Technical Note 3: Response to WSP Comments

Site: 19 Farncombe Road, Worthing, West Sussex
Prepared by: Laura Jagiela
Approved by: Phil Allen MCIWEM C.WEM
Date: 29th January 2026

- 1.1 This technical note has been produced by Motion to discuss the WSP's comments relating to the drainage strategy on consents AWD/1522/24 and AWD/1567/24, which relate to at 19 Farncombe Road, Worthing, West Sussex.
- 1.2 WSP's comments are as per the following:
- ▶ We request confirmation that a winter CV value of 1 has been used in the drainage calculations as the initial rainfall details state a value of 0.840 but each individual storm states a value of 1.
 - ▶ In addition, we require clarification on why the half drain time has not been calculated.
 - ▶ Finally, the calculations allow base infiltration within the proposed soakaway; however, the calculations should only allow for side infiltration due to the likelihood of the base of the soakaway silting up over time.
- 1.3 This technical note reviews the comments received and outlines any amendments made in response.

Figure 25.6 of the CIRIA SuDS Manual – Effect of silt on performance of infiltration

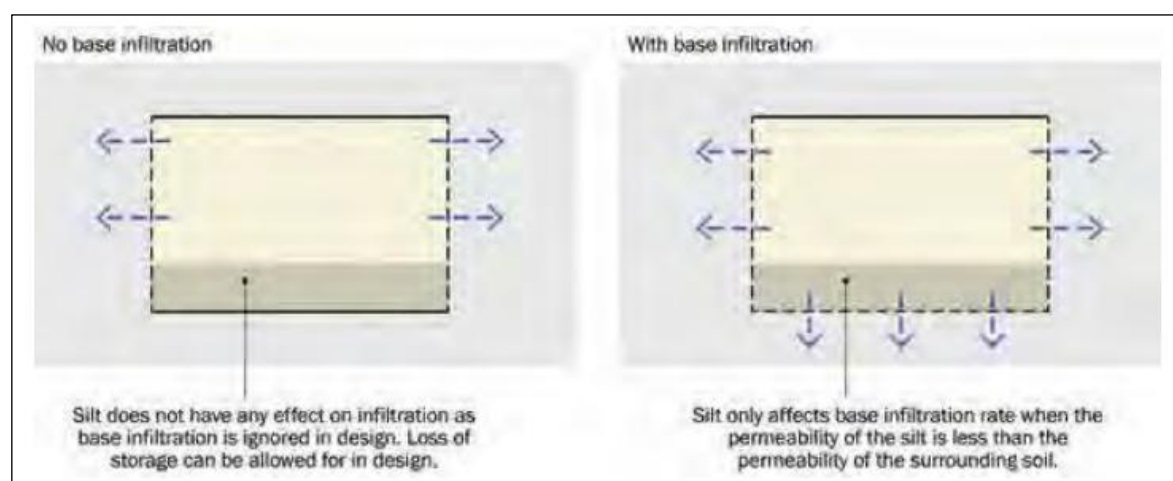
3.7 Section 25.4 of the CIRIA SuDS Manual Guidance outlines the impacts of siltation on the performance of infiltration systems, comparing scenarios with and without base infiltration.

3.8 Figure 25.6 of the CIRIA SuDS Manual (see below) states that 'Silt only affects the base infiltration rate when the permeability of the silt is less than the permeability of the surrounding soil'. It further notes that 'If the surrounding soil has similar permeability to the silt then there will be little effect'. Silt typically has a permeability of around 1×10^{-6} m/s.

3.9 The soakaway that has been designed for 19 Farncombe Road has an infiltration rate of 1.17×10^{-6} m/s, which is slower than that of silt. As a result, the impact of siltation on systems performance is expected to be negligible.

- 3.11 Overall, Section 25.4 of the CIRIA SuDS Manual confirms that siltation effects will be negligible at 19 Farncombe Road and restricting the design to side infiltration is not justified.
